AN 435-05 Lonergan Bus Property  
SUB 05-6-543

RE: Lonergan Property  
Subdivision, Special Exception and Site Design Review

This office has reviewed the additional information submitted on March 17, 2006. The applicant has satisfied the 10 % calculations. However, sheet C-3 of 9 shows the alleyways behind the townhouses as partially pervious. Please clarify as the City's policy precludes this.

Enclosed are eleven (11) copies of the Basheer/Edgemoore-Properties, L.L.C. (the "Applicant"), third revised plans for "1109 Boucher Avenue – Planned Development, Site Design, and Subdivision" (the "Plans"). There are no revisions to the "Stormwater Management Report" dated February 6, 2006 and revised on February 16, 2006. Attached to each set of Plans are the responses provided by the Applicant to the comments you e-mailed on February 24, 2006, your verbal comments given to Robert Fernandez on March 6, 2006, confirmed by e-mail on March 7 (a copy is attached) regarding the Applicant's applications for a Residential Planned Development. The comments/requests are in bold, followed by the Applicant's point-by-point responses.

**EXISTING CONDITIONS**  
**1109 BOUCHER AVENUE**  
CITY OF ANNAPOLIS  
6TH DISTRICT

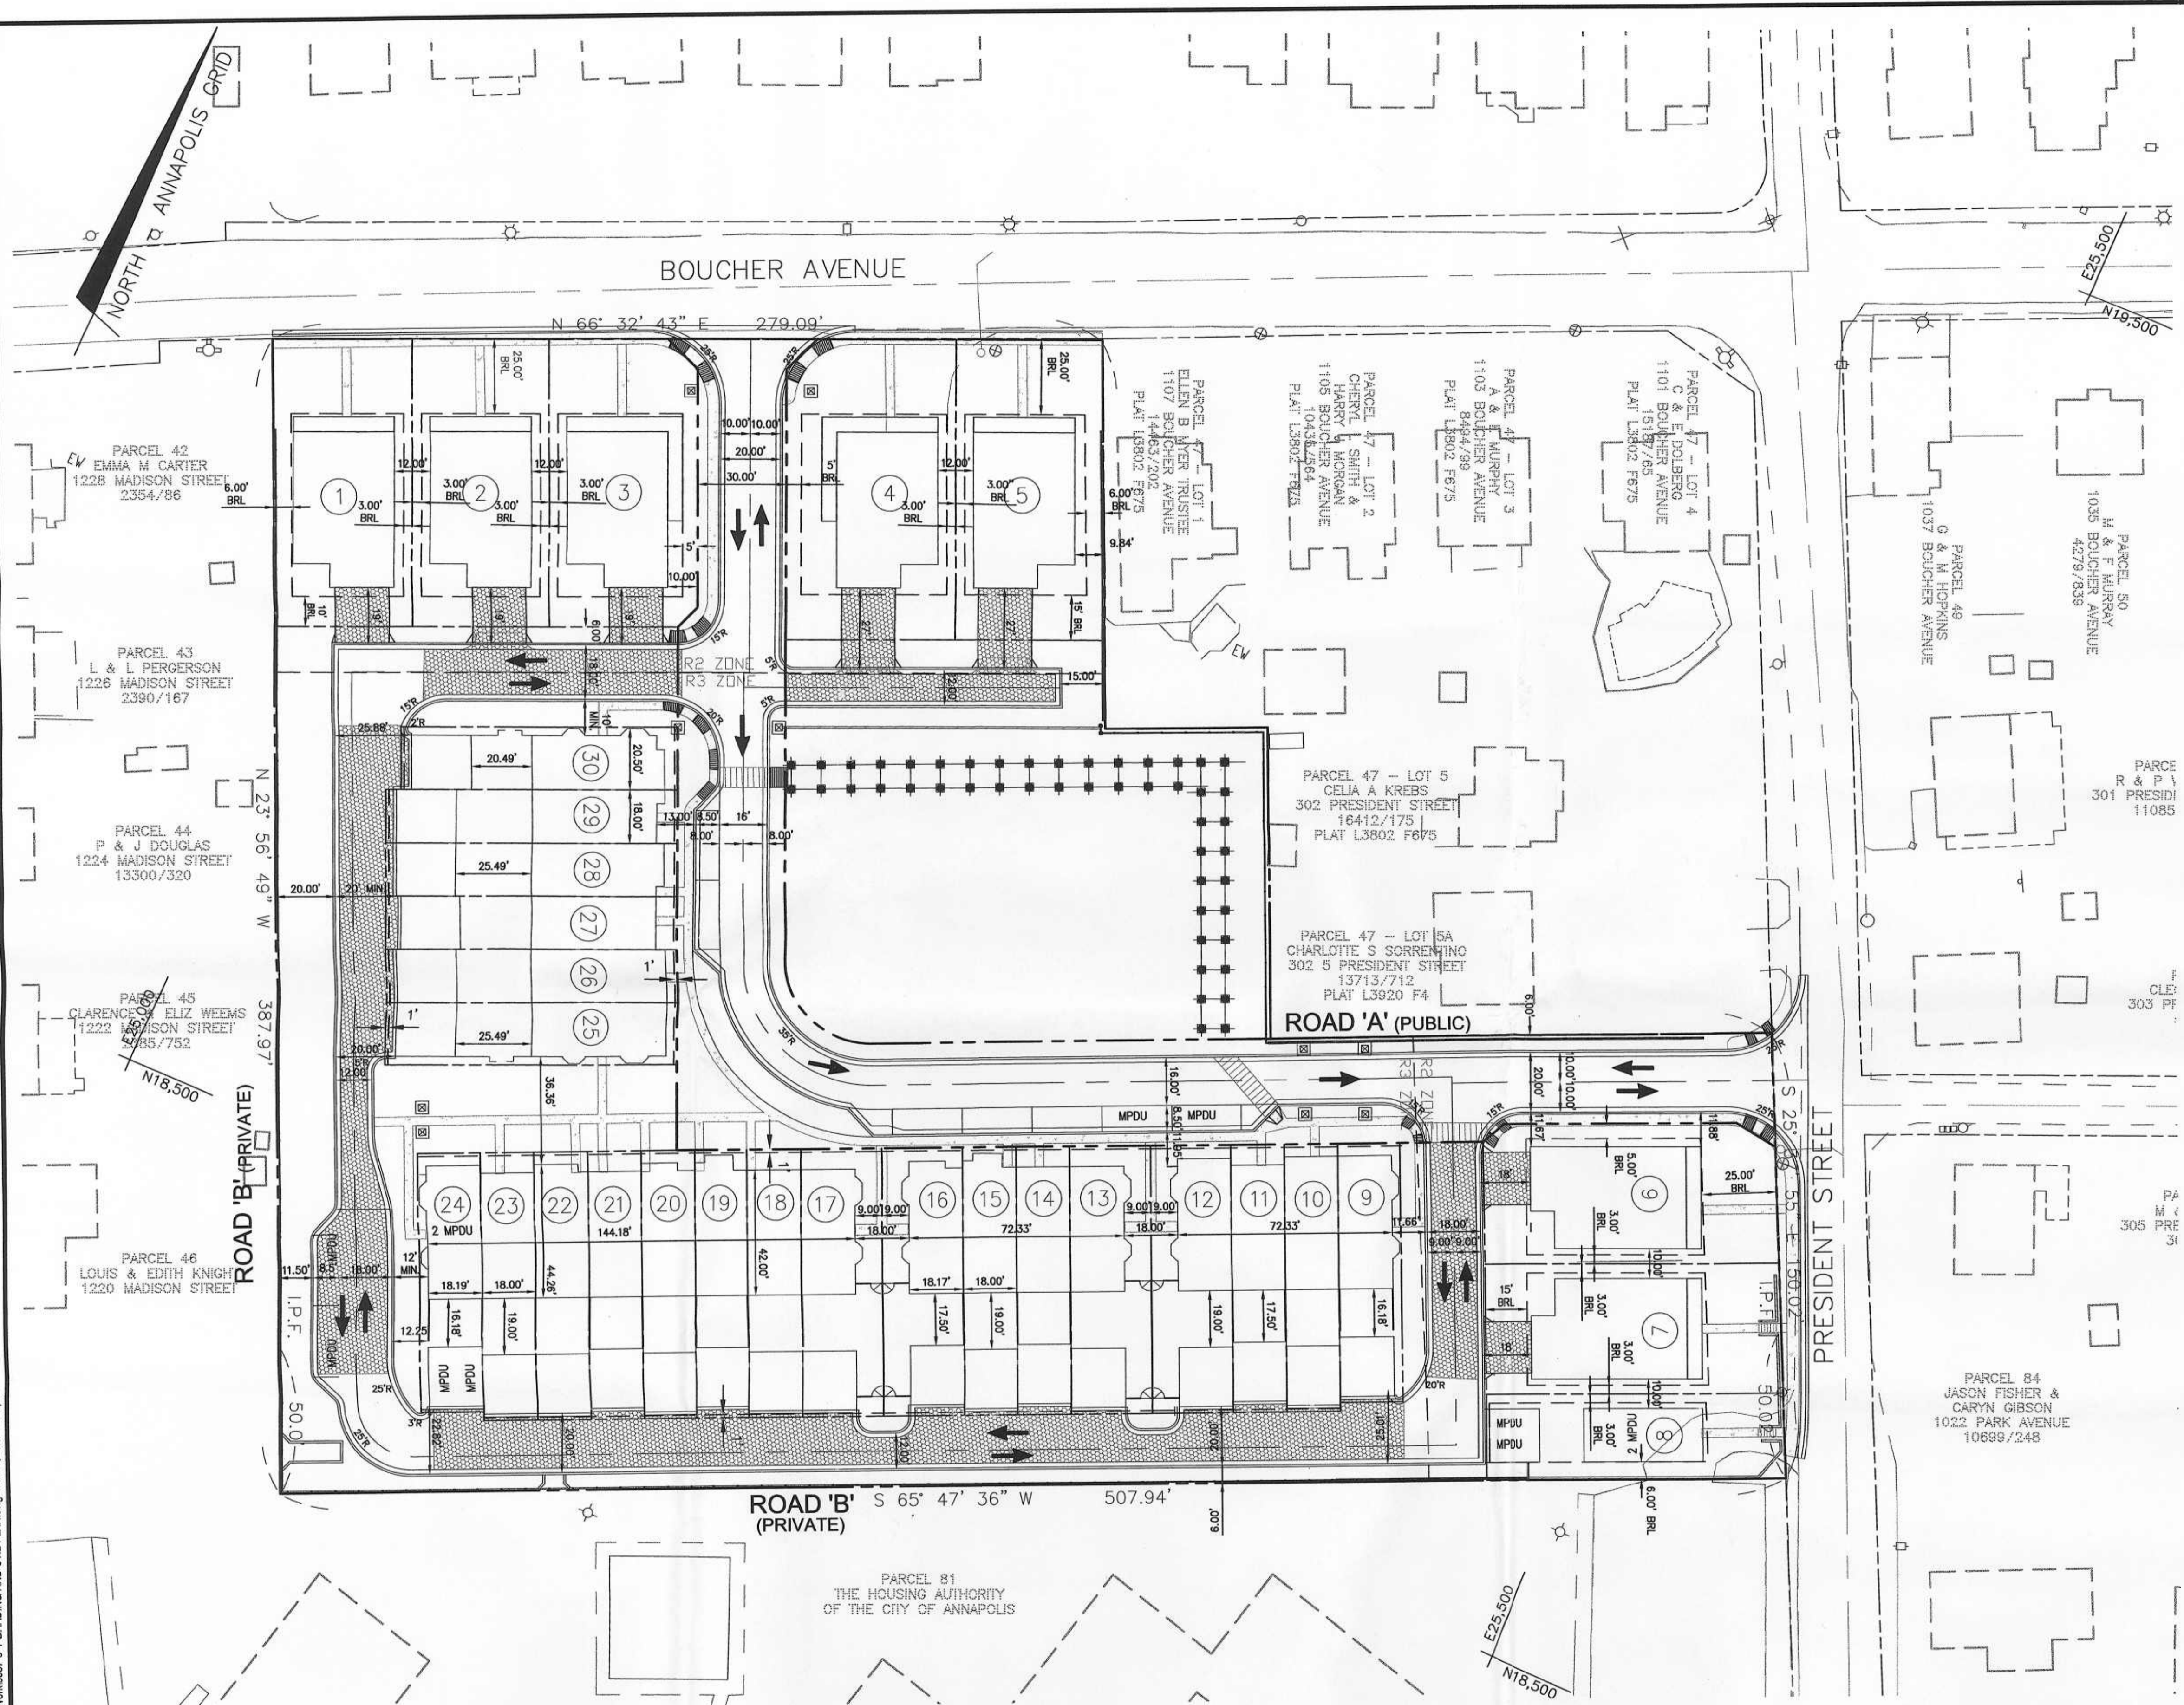
**1. Note existing trees to be saved or transplanted. Try to save more trees.**

**1. Show underground storage tanks and what action has been taken regarding them.**

Due to the previous industrial use of the site, most of the trees on the site are poorly shaped and are in generally poor condition. Trees in good condition and in suitable locations will be saved and they are indicated on Sheet C2. A letter documenting this evaluation will be provided at the Planning Commission meeting on April 6. ) ↙

Trees that will enhance the aesthetic quality of the landscaping plan and which are to be saved are identified on Sheet C2.

See Sheet C2.

Service has been terminated and abandonment locations are indicated on Sheet C2.

SHEET C3 OF 9

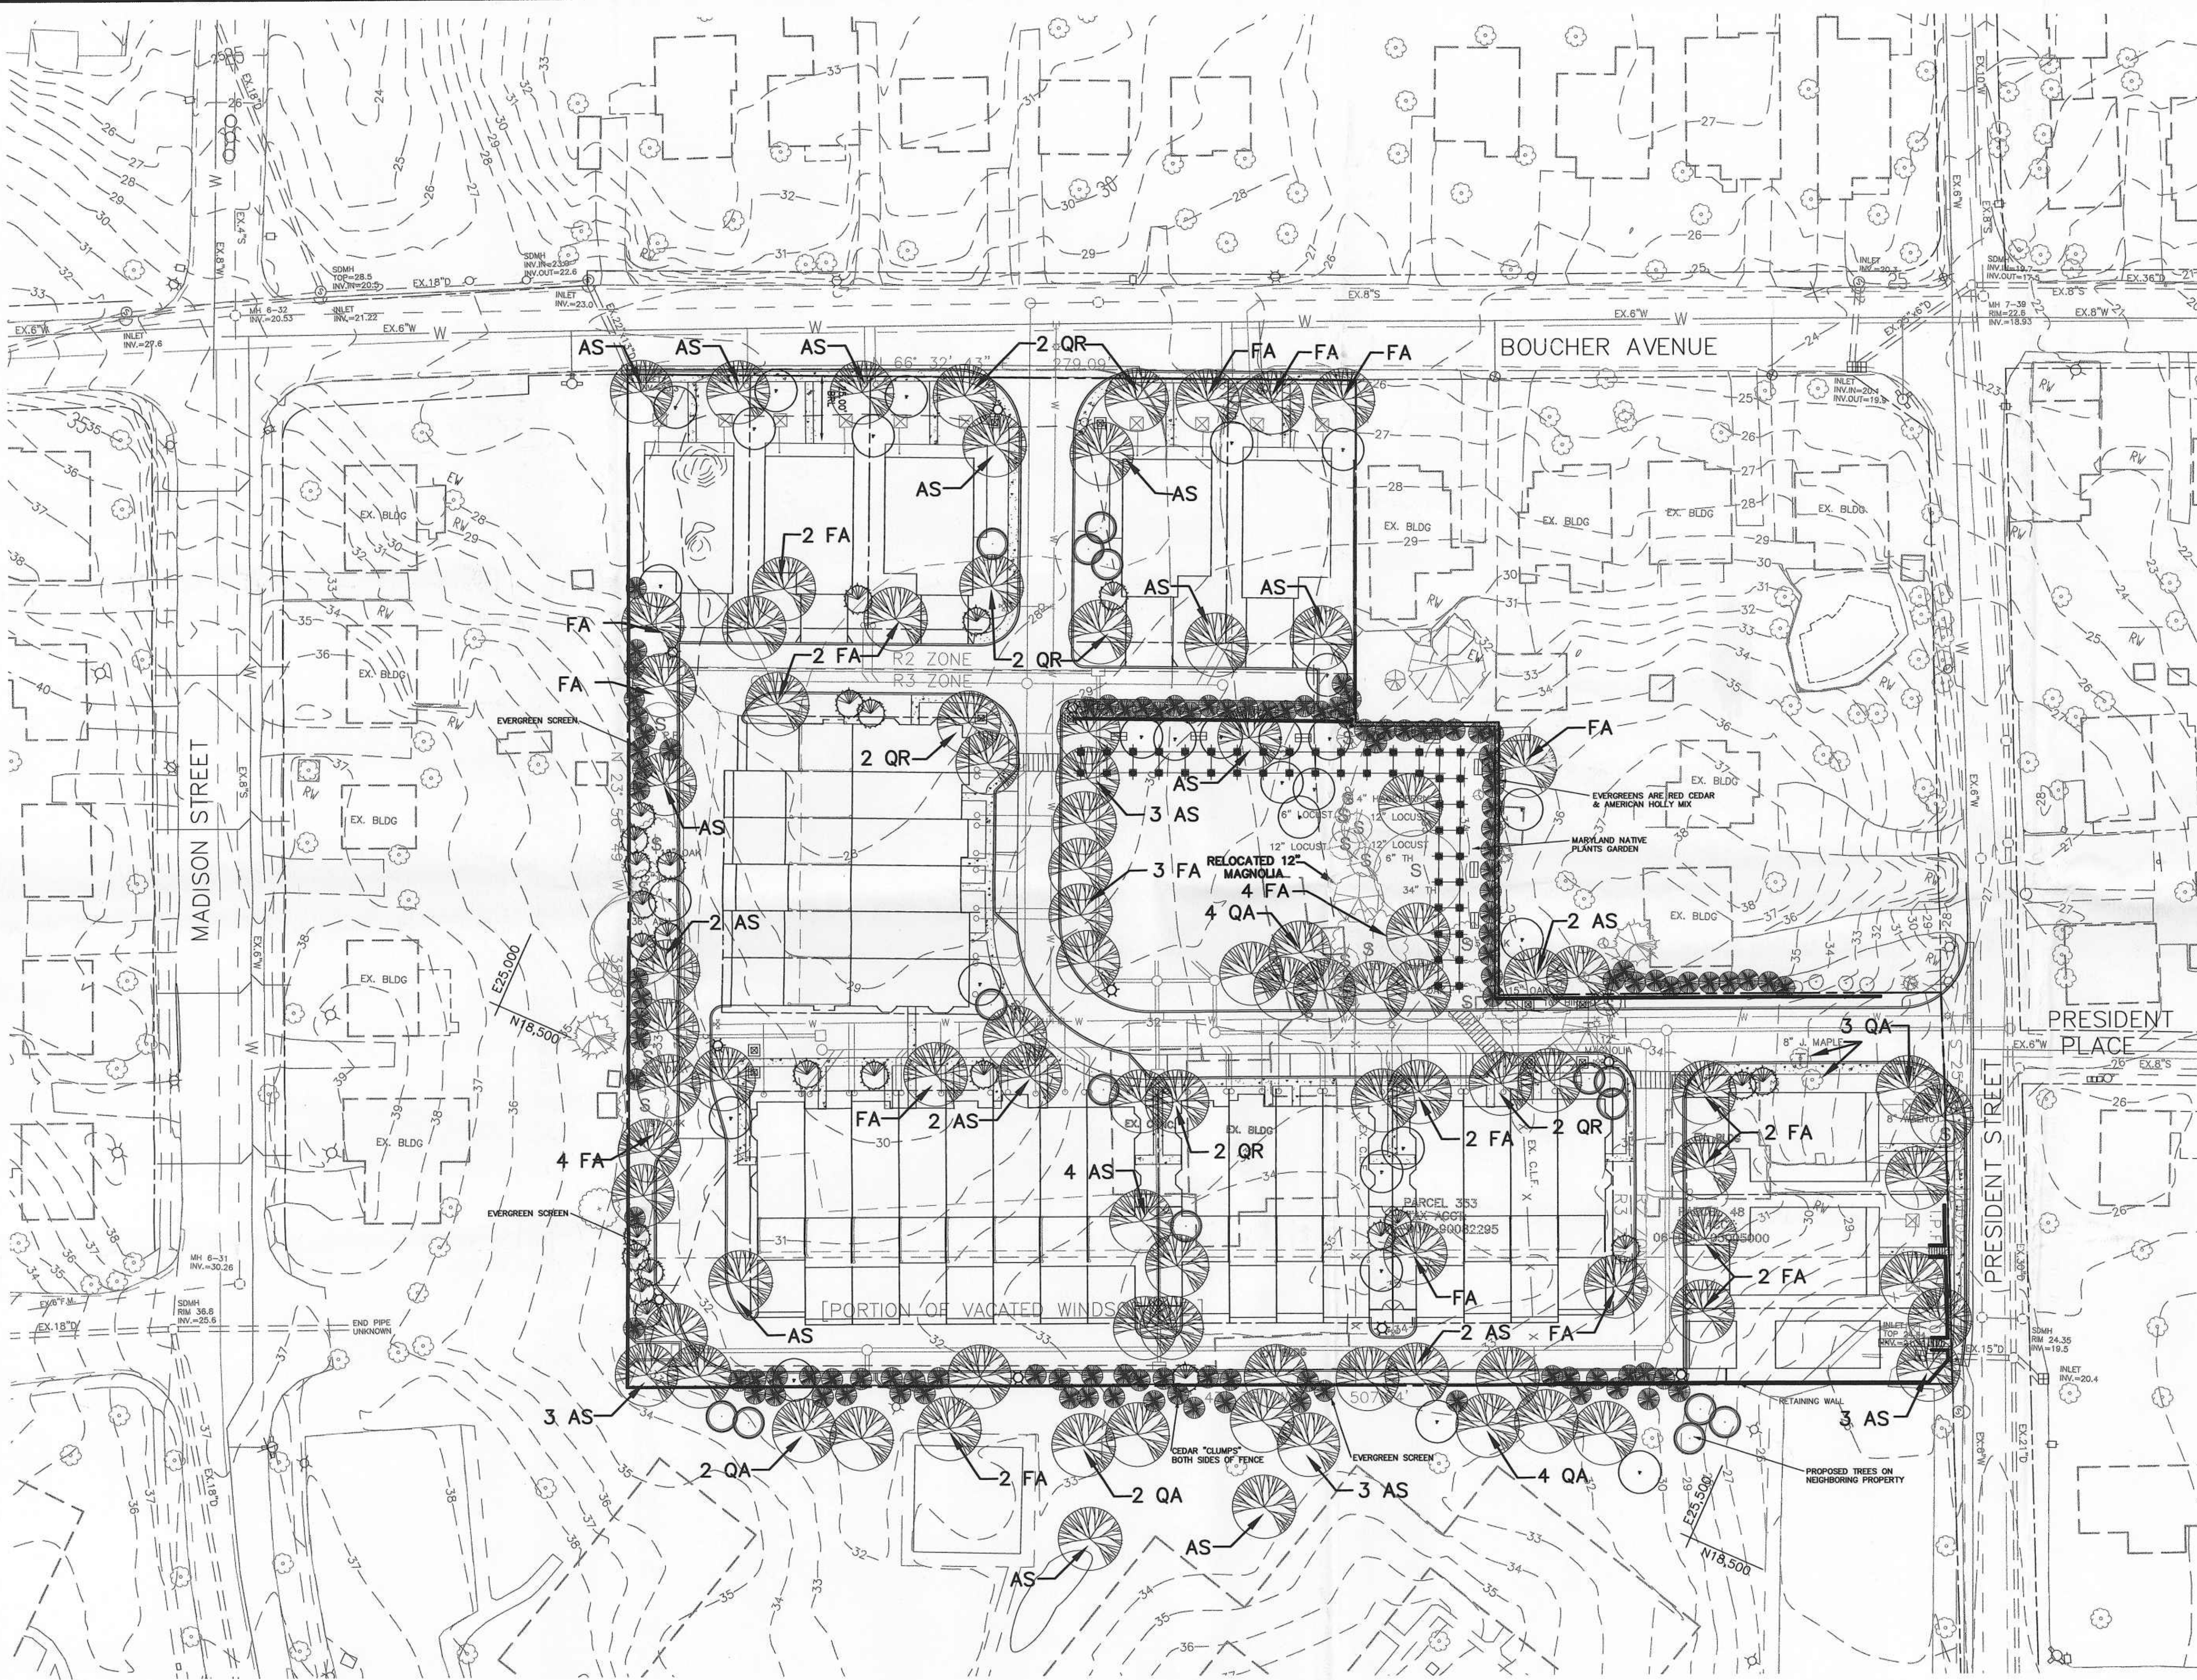
**5. Sheet C3 of 8 notes that lots 1-7 accommodate 4 parking spaces per lot. However, Lots 1, 2 & 3 delineate a 15 ft. driveway behind the garage, of which 2 ft. is beyond the fee-simple lot line into the alleyway. Lots 6 & 7 delineate a 16 ft. driveway behind the units.**

**7. Please delineate the proposed MPDU units and their proposed parking spaces on the site plan.**

**10. Please remove the two parallel parking spaces along the alleyway within Open Space 'C', adjacent to Unit 24. The 20 ft. buffer should be maintained along the entire property line.**

**1. Revise the ecostone limits as shown. Private alley use limited to rear of single family lots**

**7. Use the Kingsport alley detail. Try to eliminate curb and gutter in alley. Use the standard driveway apron at each end of private alley.**

See revised Sheet C3. Bowman Consulting has adjusted the driveway dimensions for Lots 1-3 and 6-7 so that all 5 houses have 18' deep driveways clear of the 18' alley width.

At the Applicant's last meeting with Jon Arason, it was suggested by Mr. Arason and agreed to by the Applicant that the MPDU units would be in Units 8 and 24 and that each of these two structures would contain two MPDU units. Bowman Consulting has indicated the information requested on revised Sheet C3.

Two parking spaces are proposed at the southern end of the west leg of the alley (Road B). Along most of this leg of the alley, there is a 22' wide planting area. At the location of the two parking spaces, the planting area is 11.5' wide, which can accommodate evergreen and deciduous plantings as indicated in the application. Further, the area adjacent to Lot 24 is 12.5' wide and can also accommodate the plantings and lead walk as shown in the application. After careful consideration by the design team, the Applicant proposes that the two parking spaces remain in their present location, as this is the optimal design.

Stormwater is managed in the alley (Road B) with semi-pervious pavers on a gravel retention bed and curb inlets to the internal storm sewer to handle water overflow. Due to the urban nature of this site, it is not practical to manage stormwater as sheet flow due to limited area, as was done in Kingsport alleys. It is also not practical to convey water in an open section swale as this would result in greatly reduced planting areas. The alley section detail as indicated is the best solution for this site.

DATE	DESCRIPTION
	KVM RMF
	DESIGN DRAWN CHKD
	SCALE: H: 1"=30'
	V: 1"=30'
	JOB No. 3537-01-001
	DATE: MARCH 13, 2006
	FILE No.
	SHEET C8 OF 9

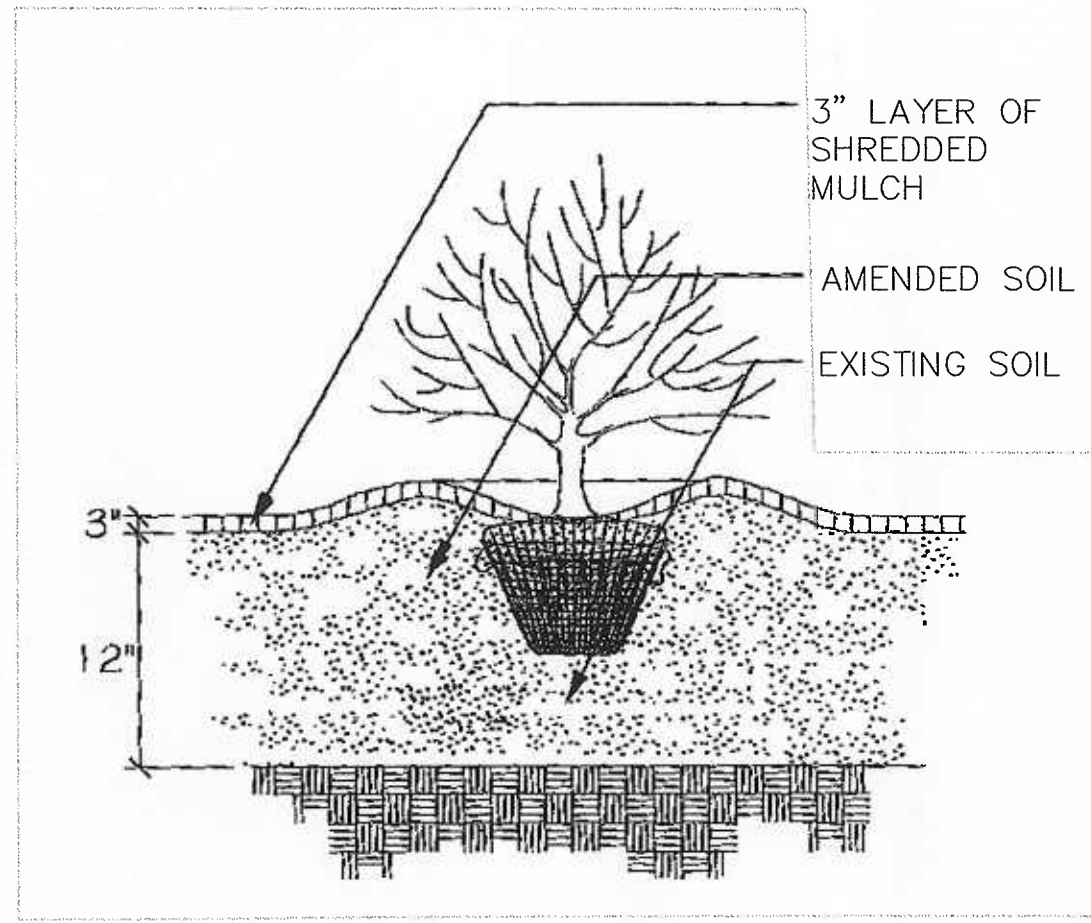
**1. Some of the proposed trees are shown too close together. Ok to lose some and pay a fee-in-lieu for replanting.**

The landscape design will be coordinated with DNEP and the landscape architect during final engineering. If DNEP determines adequate space for planting is not available on-site, a fee in-lieu of the respective planting will be paid.

The proposed park in the center of the site is designed with a pergola covered perimeter walk, benches, and landscaping as shown in the plan and detail of Sheets C8 and C9.
